złączka Makita 459222-3 (422617-3)

DC179

Title	Change of Arm set, Joint, Hose connector, Dust nozzle Elimination of O ring 20, O ring 23 Addition of Rivet 7
Model	DSL800, XLS01
Country	All countries
Description	To improve the dust collecting efficiency; • Arm set, Joint, Hose connector and Dust nozzle will be changed. • O ring 20 and O ring 23 will be eliminated. • Rivet 7 will be added.

[1] Arm set (183L76-5)

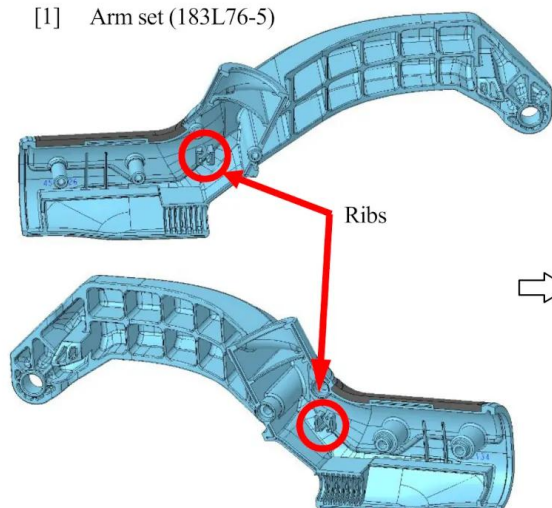
Arm set (183T15-3)

[2] Joint (459222-3)

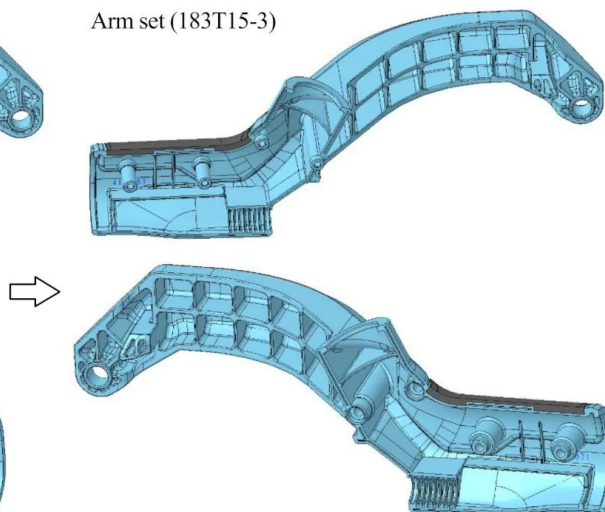
Joint (422617-3)

- [4] Elimination of O ring 20 attached to the current Joint
- [5] Elimination of O ring 23 attached to the current Joint

[6] Dust nozzle (459234-6)

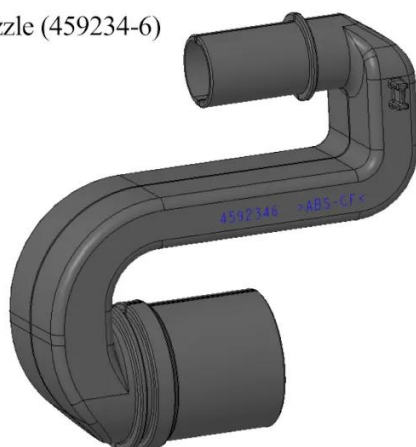
Dust nozzle assy (127672-7)
